**ADDENDUM NO. 4**  
**ITB #20-02-09, Audio Video Systems**  
**March 10, 2020**

The Invitation to Bid for "Audio Video Systems" is hereby amended/clarified as outlined in the following manner for JCDH Guy M. Tate Building, Lobby/MIS Modifications, Conference Room A and B Audio Visual Systems:

SHEET TITLE: **AV7.1**  
 AV SYSTEM SINGLE LINE DIAGRAM

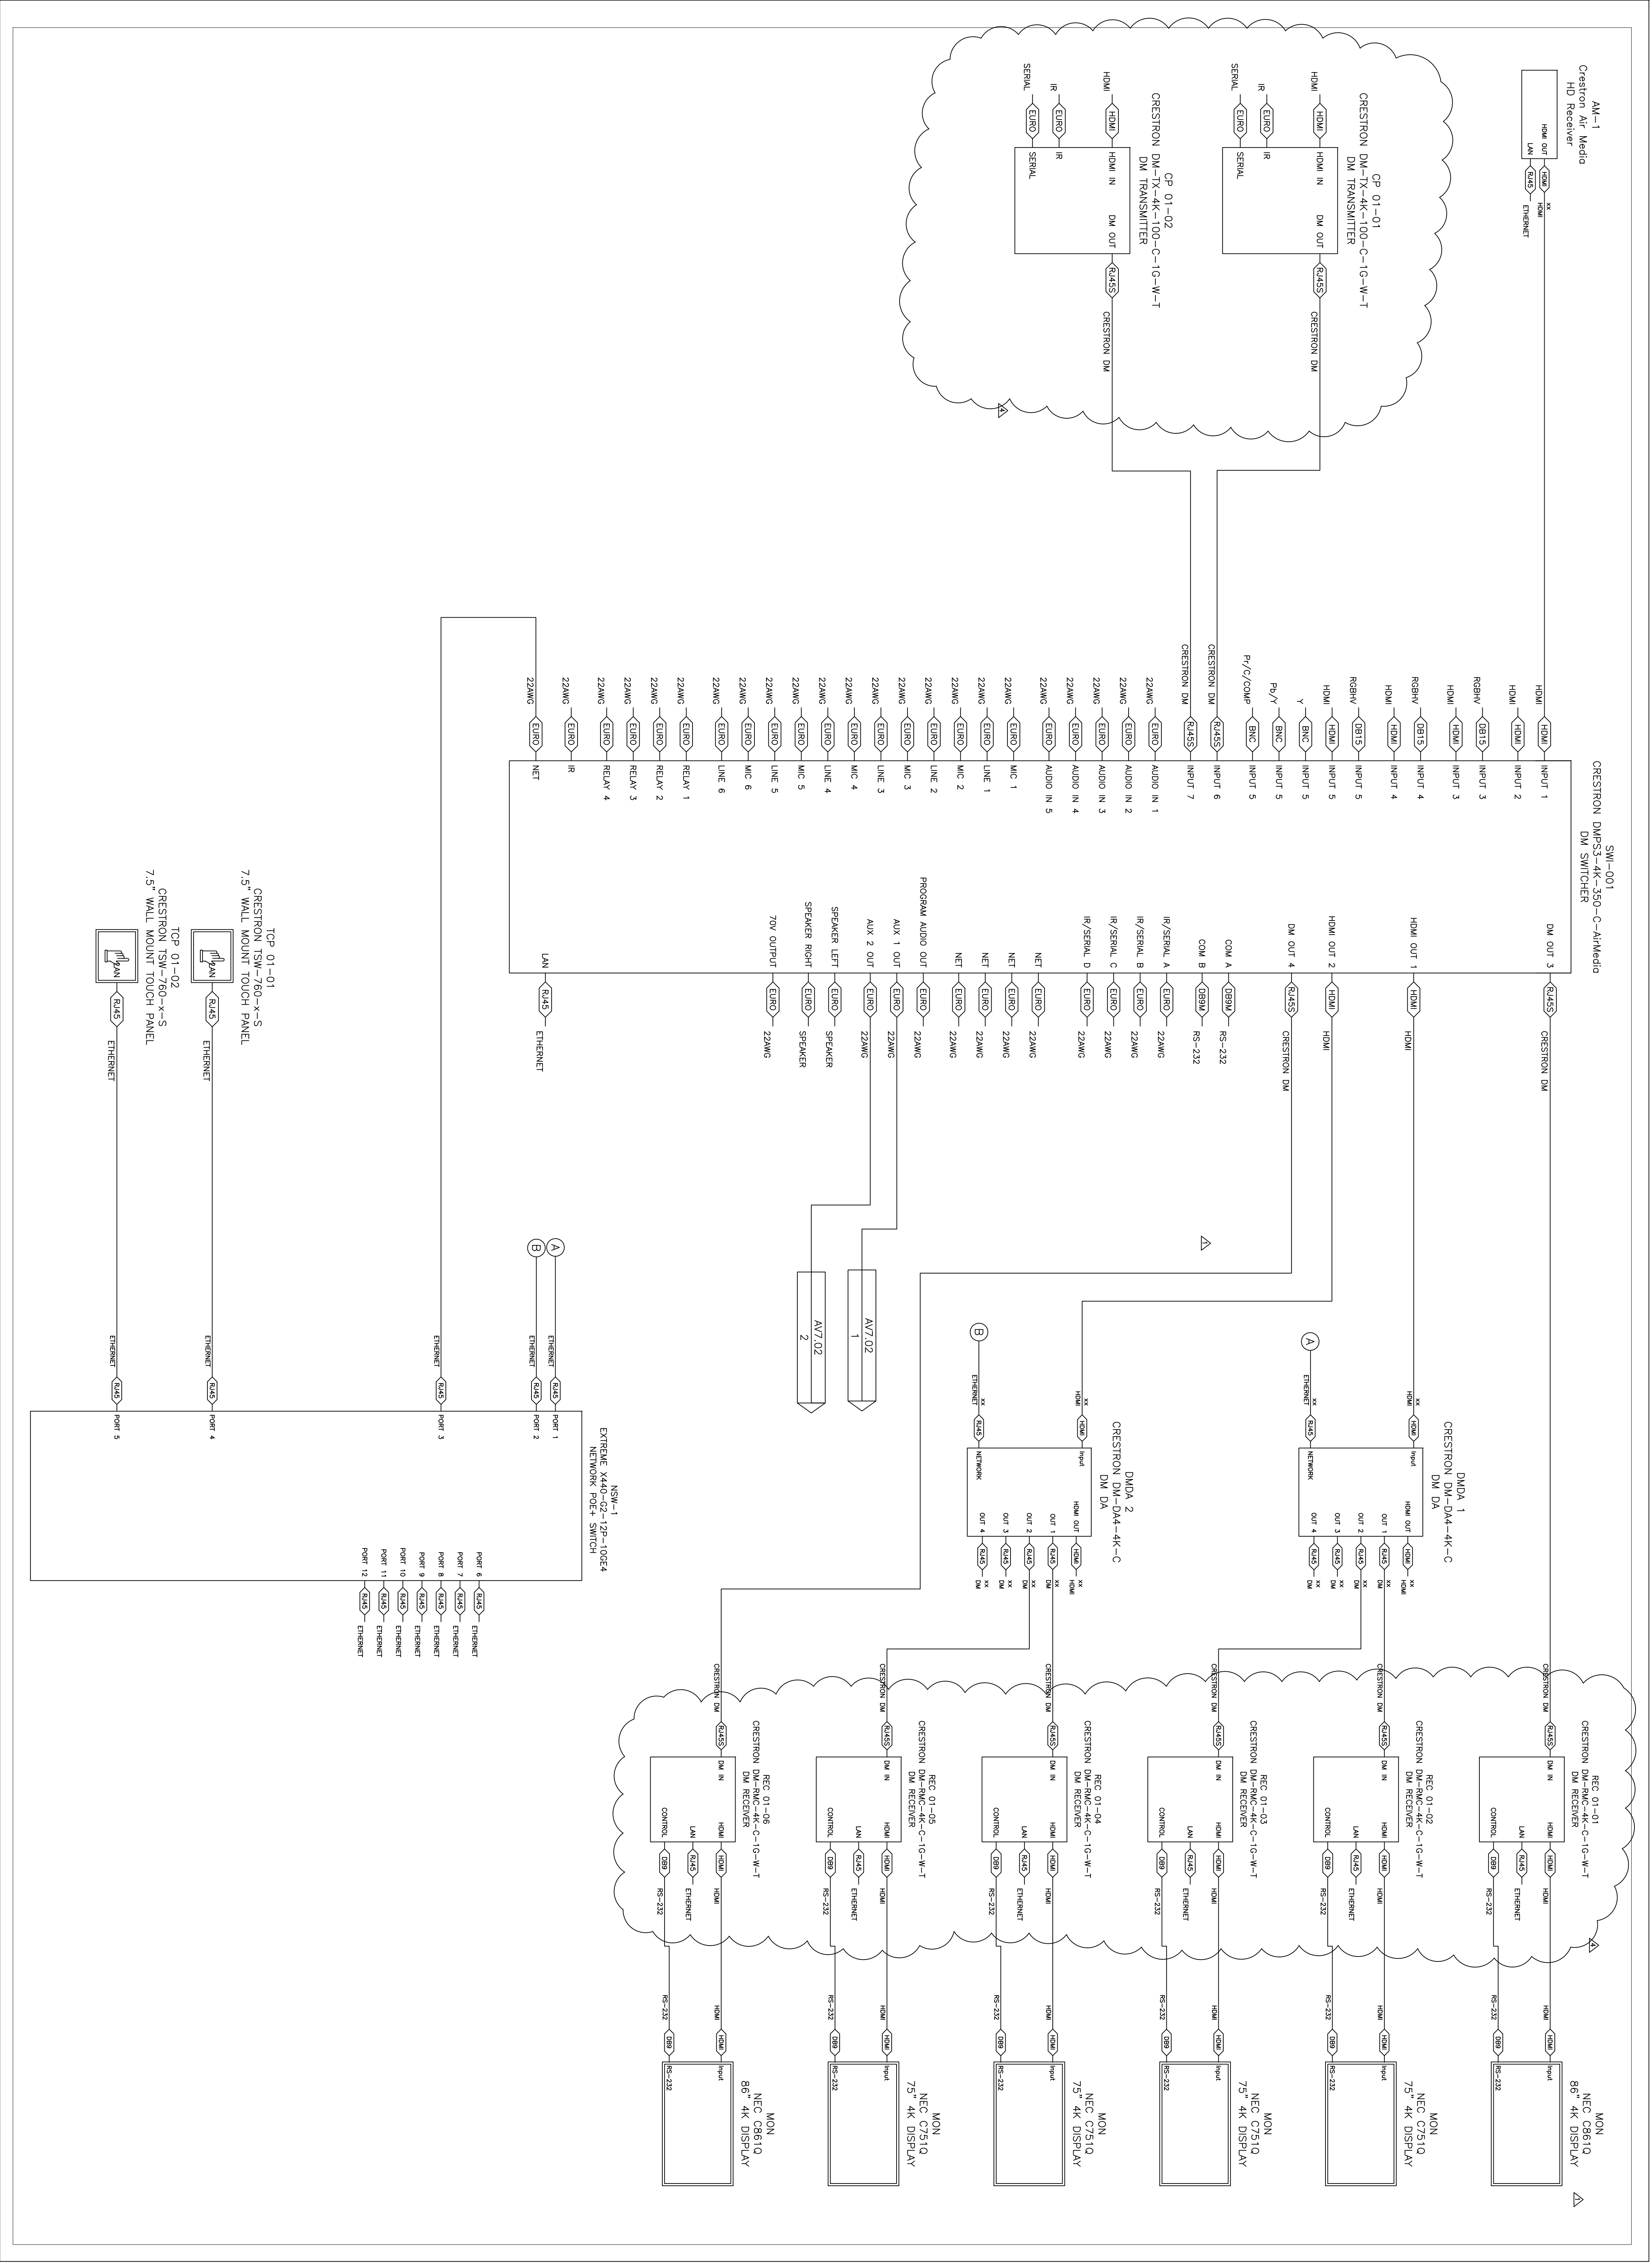
General – Video equipment specifications have been changed to provide a UHD 4K signal to all displays and to accommodate the ADA space requirements for the thinner display mounts.

Drawing AV7.1 has been revised under this addendum and is available for review.
